AUI Architecture and ILT signaling

Addressing Draft 1.1 comment #516, #508, and
perhaps others

Matt Brown, Alphawave Semi
Adee Ran, Cisco
Leon Bruckman, Nvidia

Figure 176-2—200GBASE-R 8:1, 400GBASE-R 16:2, 800GBASE-R 32:4, 1.6TBASE-R 16:8 PMAs functional block diagram

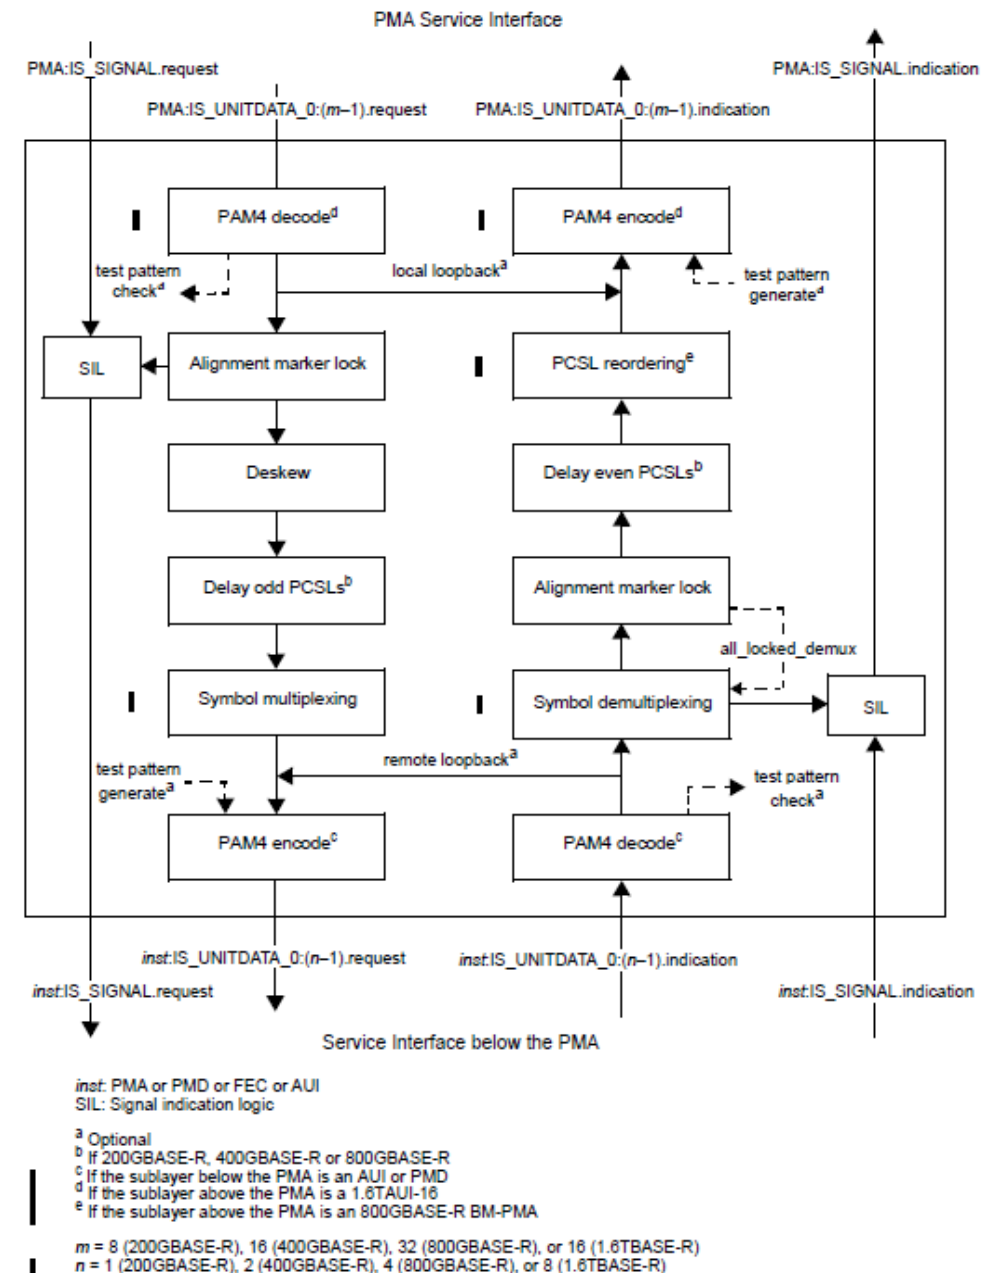
For 802.3dj, the CDR and signal driver is no longer part of the PMA. Instead, given the AUI components are equivalent to the PMD, these functions are now implicitly within the AUI.

However, these details for the AUI have not been provided in Draft 1.1.

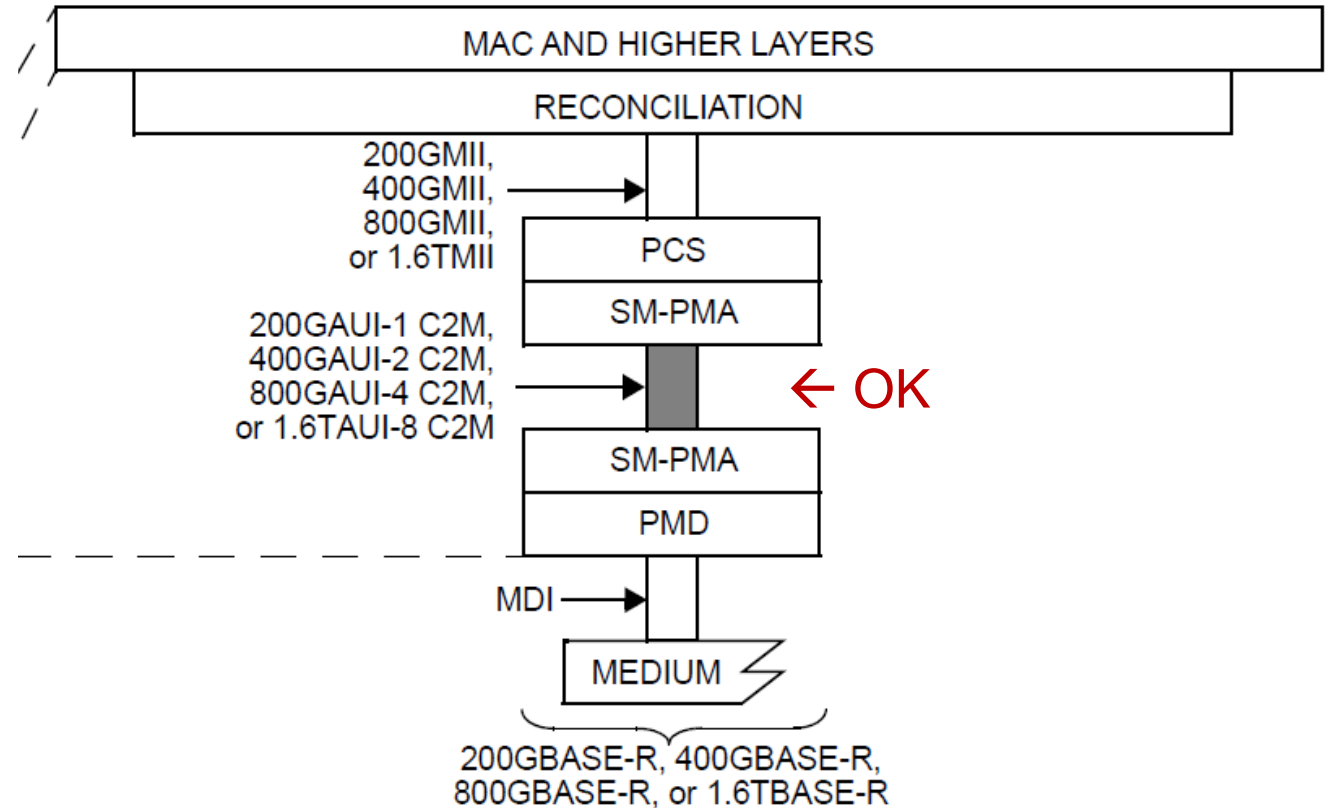
The xAUI-n can be modelled as an architectural element between a pair of PMAs.

No change for PHY stacks.

Figure 176D/E-x—Inter-sublayer service interfaces for a 200GAUI-1, 400GAUI-2, 800GAUI-4, 1.6TAUI-4 C2C/C2M

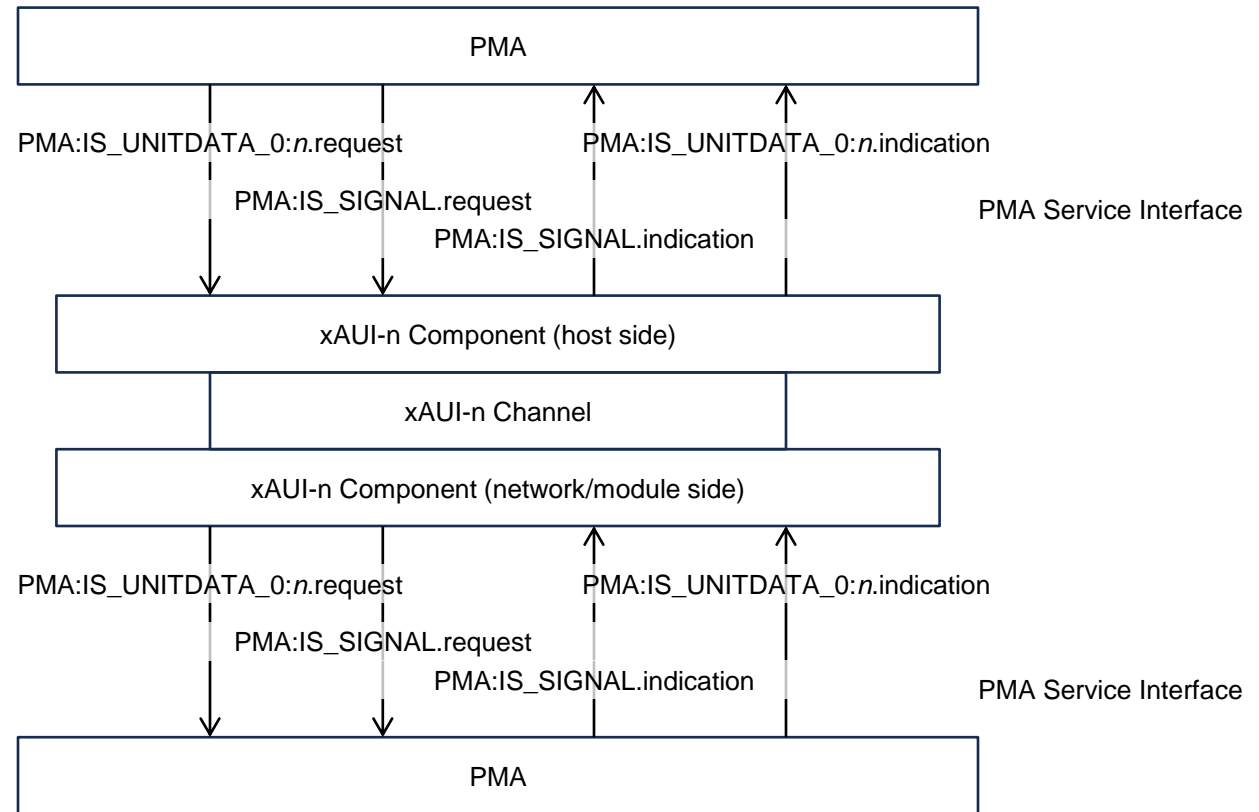
However, as noted earlier, an abstract messaging conduit between the xAUI-n and the PMA above and below is required.

A supporting diagram and text should be provided in each xAUI-n annex.

Add the diagram to the right to Annex 176D and 176E in a new subclause defining the service interfaces.

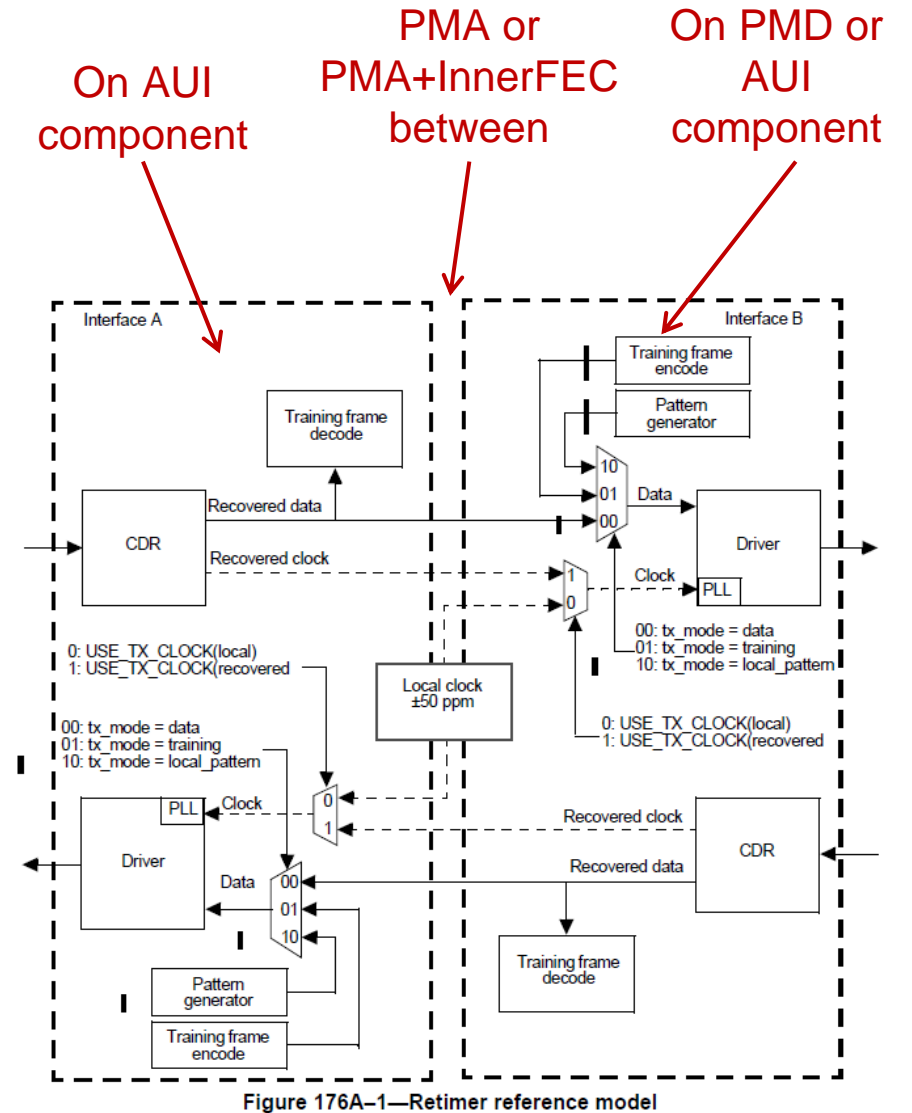
The ILT function includes provision for careful sequencing of clock source and data source.

It is currently depicted as though the two interfaces are within the same sublayer.

However, as shown on the previous slide there is another sublayer between.

Text and/or diagrams are needed to convey this.

Figure 176A-6—RTS update state diagram

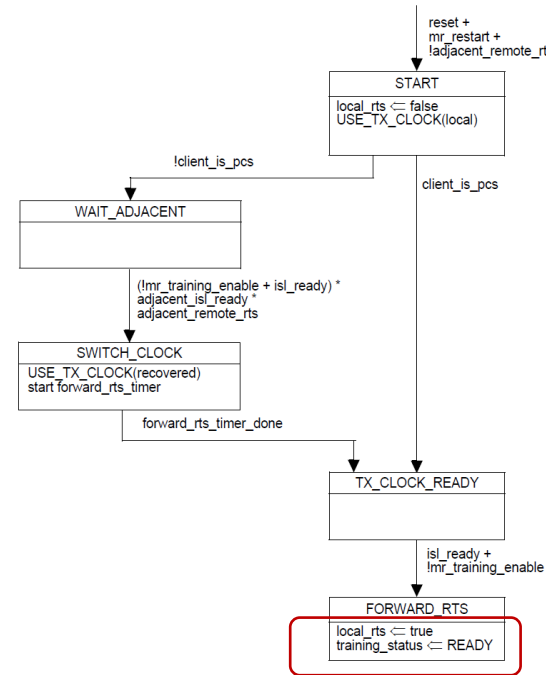
The editor's note points out that the location of the Figure 176A-6 state diagram needs to be specified. Given that there is one per interface and since the ILT function is part of the PMD or AUI component the location is implicit.

Delete the editor's note.

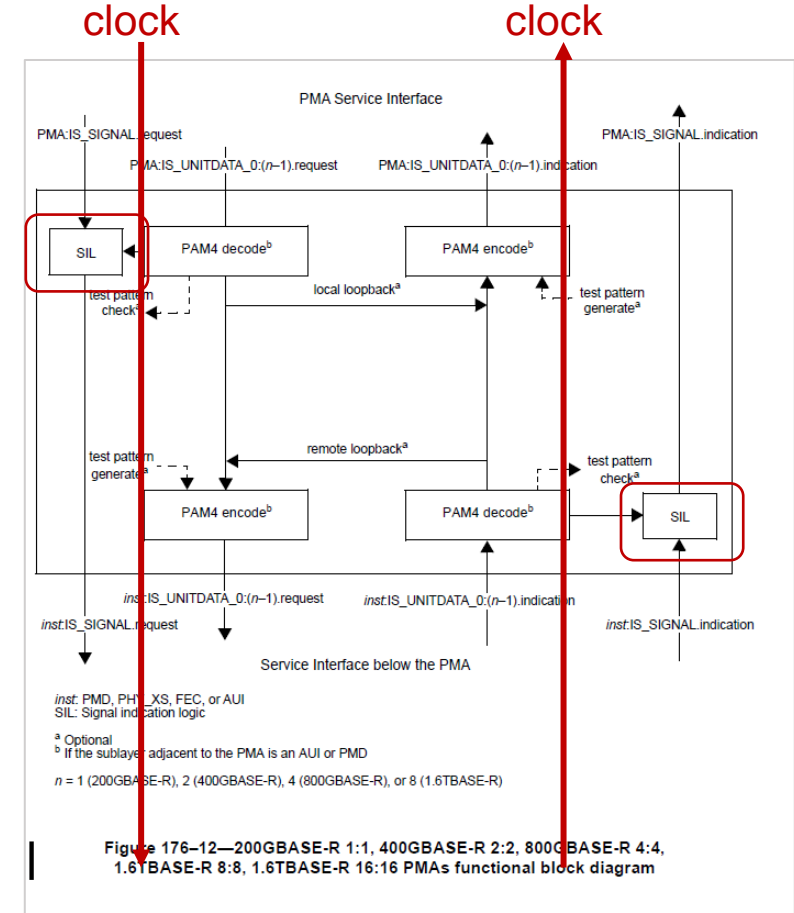
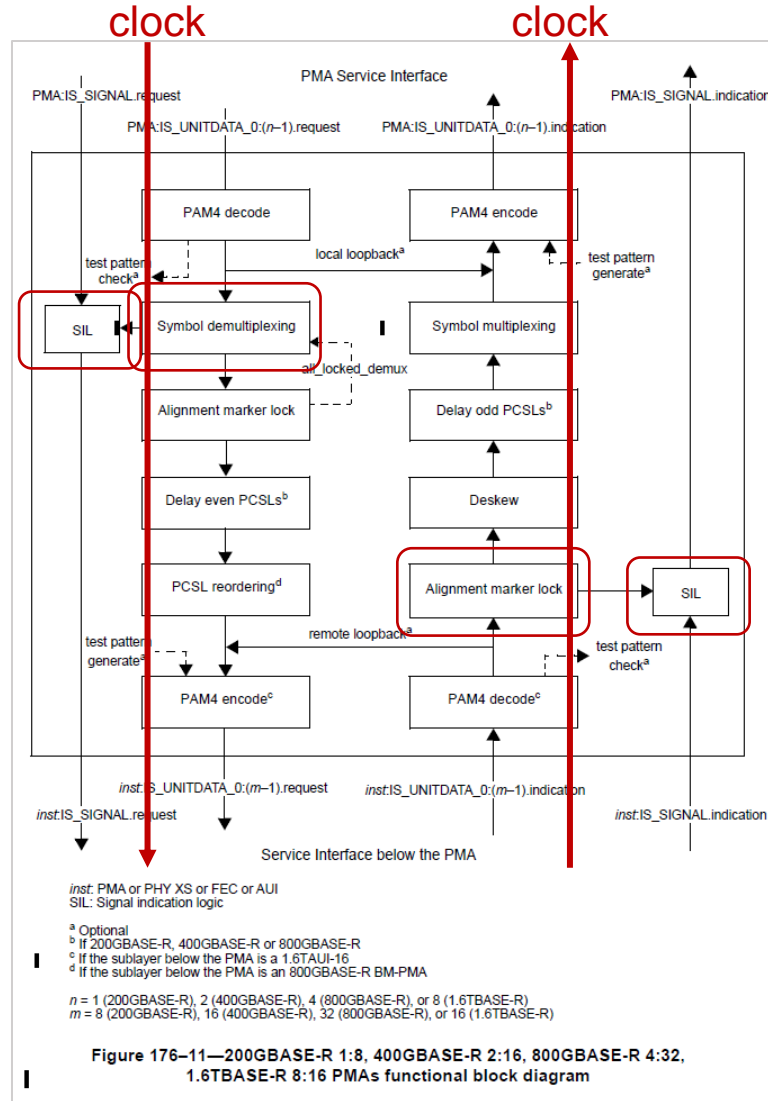
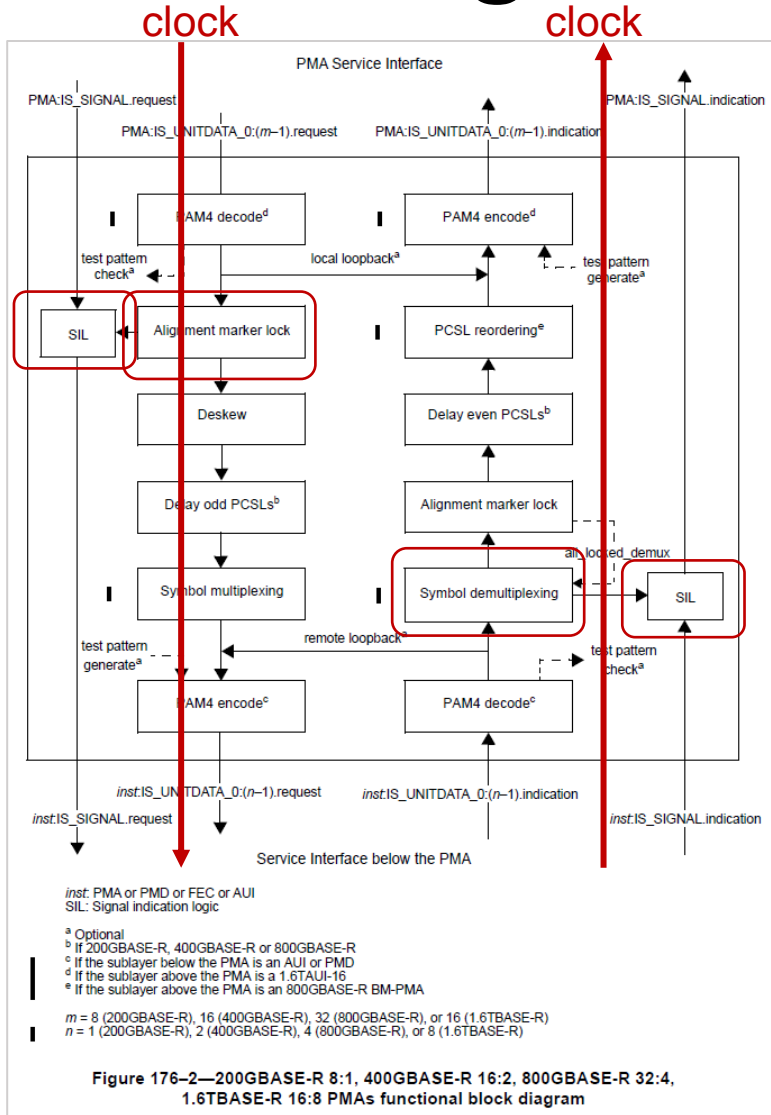
The variables `adjacent_remote_rts` and `adjacent_isl_ready` are defined in Draft 1.1 as shown top right.

These are not sufficiently complete.

Change these definitions as shown in the bottom right.

Boolean variable that indicates the value of `remote_rts` on the other interface of the device. It is set to true if the parameter `SIGNAL_OK` is OK and is otherwise set to false.

Boolean variable that indicates the value of `isl_ready` on the other interface of the device. It is set to true if the parameter `SIGNAL_OK` is OK or `READY` and is otherwise set to false.

NOTE – `SIGNAL_OK` is received via the `IS_SIGNAL.request` primitive for an AUI component above an AUI channel or a PMD, or via the `IS_SIGNAL.indication` primitive for an AUI component below an AUI channel.
